Submission ID: 31603

Written Representation files (3no) uploaded 12/11/2024

I am pleased to submit a Written Representation to the A46 Bypass scheme.

a) Rail to soffit height of the A46 East bridge:

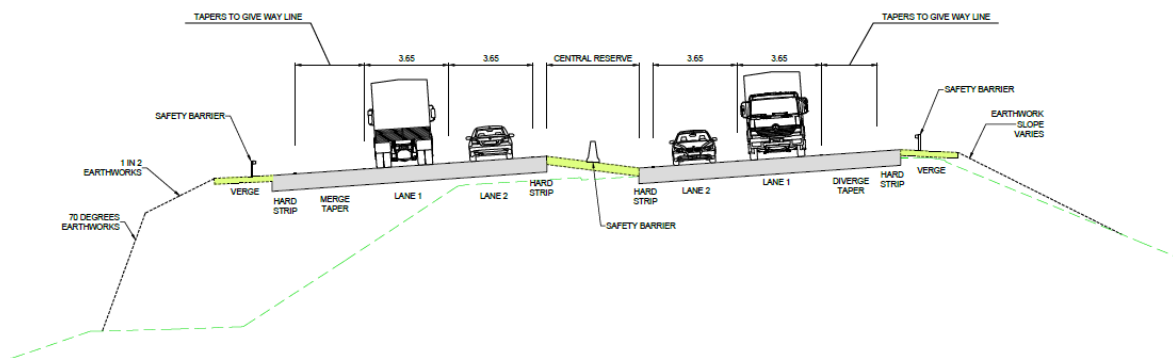
The existing rail height A.O.D. beneath the A46 East overline railway bridge on NOB1 is given as 12.3m in Elevation 1 in the D.C.O. submission documents.

The Jacobs 2016 Report, Newark Flyover Permanent Way GRIP 2 Sketch 4 gives the existing soffit height at the Nottingham end of the bridge as 17.620m A.O.D. from survey with a proviso that the whole soffit width of the overline bridge needs to be surveyed. This produces a rail to soffit height of 5.32 metres.

With a nominal 4.8 metres required rail to soffit height this gives an intended provision in the Jacobs 2016 Report to raise the railway height under the bridge by 0.52 metres and lengthen and hence lessen the otherwise severe gradient.

However as the Jacobs 2016 report cautions; the soffit measurement is at the higher side of the superelevation of the existing A46, this may produce a lower side measurement considerably less, in effect negating the intended provision.

CROSS SECTION H
DUAL CARRIAGEWAY TO THE SOUTH OF THE NOTTINGHAM TO LINCOLN RAILWAY LINE
EAST CROSSING

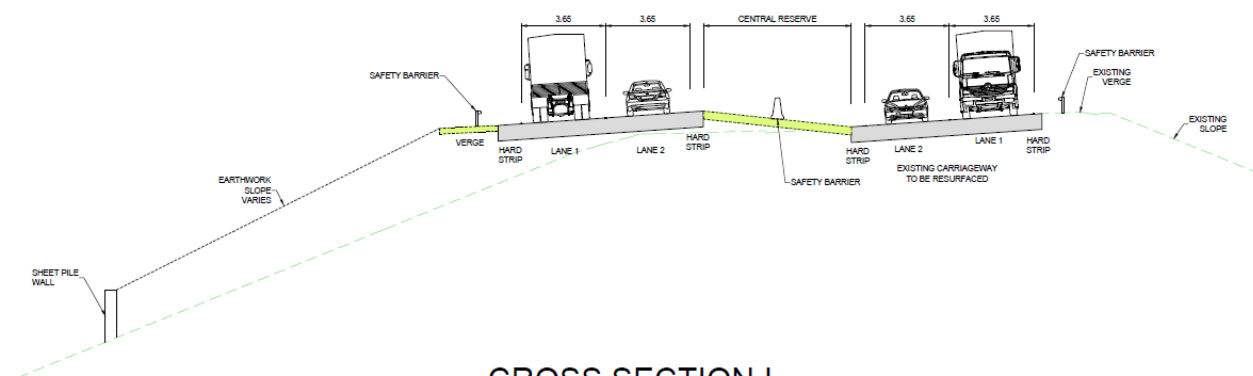
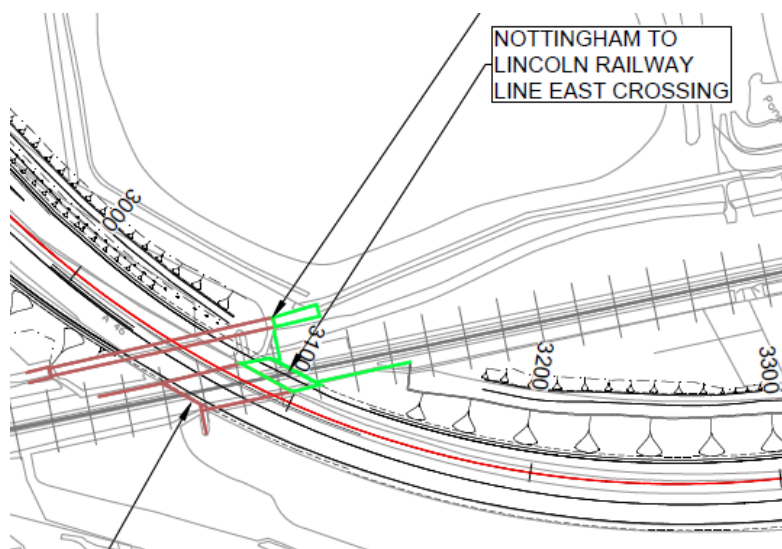
It should be noted that these cross-sections show staggered carriageways, whereas the Applicant's response to the Relevant Representation states that:

The arrangements on the cross-sections H & I above do not seem to co-incide with the plan view shown on the D.C.O. and the Applicant’s response that both seem to imply a co-planar arrangement of the new soffit with the old soffit rather than staggered separate carriageway soffits.

The concern here is that the additional bridge span in a co-planar arrangement lowers the effective soffit height when the need is to raise the soffit height to allow the railway grade to commence as early as possible on the exit from the original bridge.

Elevation 1

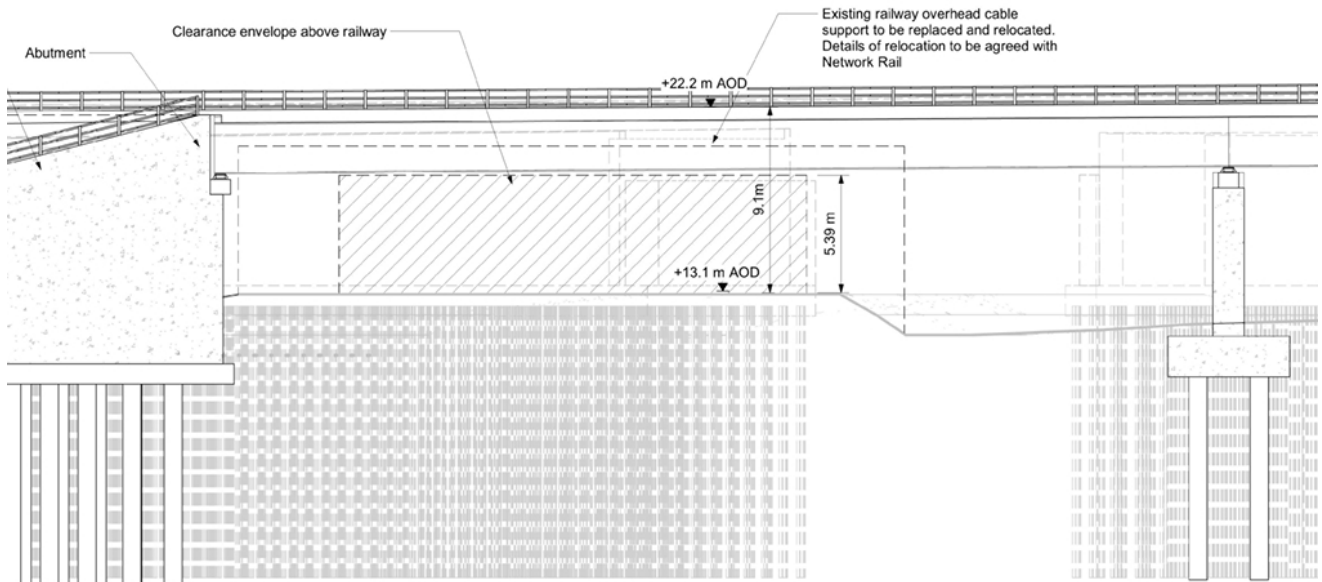
- a rail height of 12.3m A.O.D.;
- a maximum rail to soffit height of 4.79m: &
- a rail to road surface height of 7m.

This gives a construction depth of 2.21m.

It also gives an additional headroom of only 0.01m over the desirable minimum soffit height of 4.780m for the standard structure gauge.

In effect the D.C.O. Elevation 1 shows the soffit height at the new widened northern side of the bridge and the Jacobs 2016 Report shows the soffit height at the original southern side of the bridge. The difference in soffit height might be explained by the co-planar arrangement of carriageways due to the super-elevation of the road.

Thus there appears to be some incompleteness in the basic information supplied in the D.C.O. documents and also in the Atkins 2022 report with regard to the A46 East bridge over the railway.

The provision of a General Arrangement drawing of the complete bridge with the headroom and soffit heights at the existing side and the widened side shown would answer these concerns.

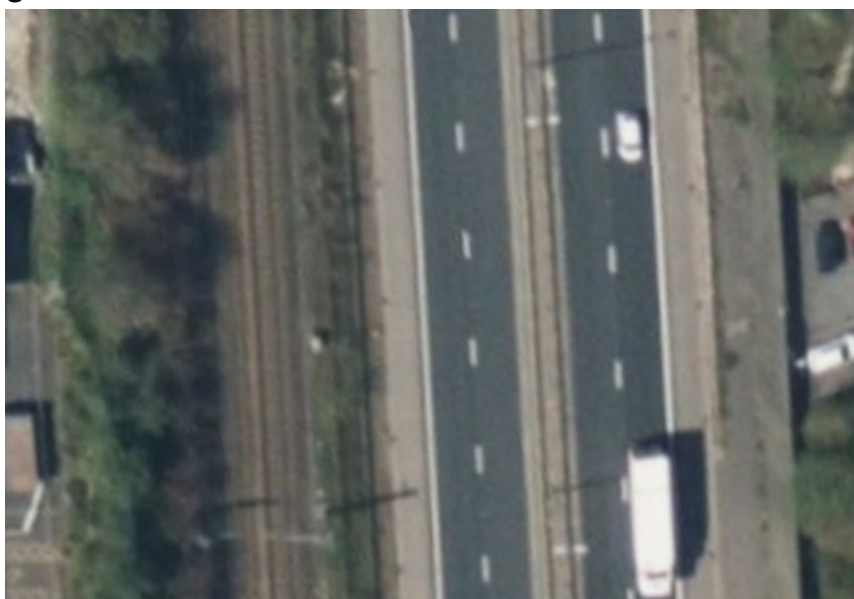
- b) Reduce the separation distance between the new railway and the new northbound carriageway of the A46 from the 11m to 7m from the running rail to the hard strip of the road. The respective distance requirements are: -

This would substantially reduce the earthworks' cost and enable the new railway to avoid passing over the Hydro-Electric Plant, thereby allowing the overall height of the railway viaduct to be reduced. It would also enable the railway to cross the River Devon Trent and the ECML and NSE railways at narrower points thereby reducing the bridge spans and potentially allowing simpler, less obtrusive bridge designs to be employed.
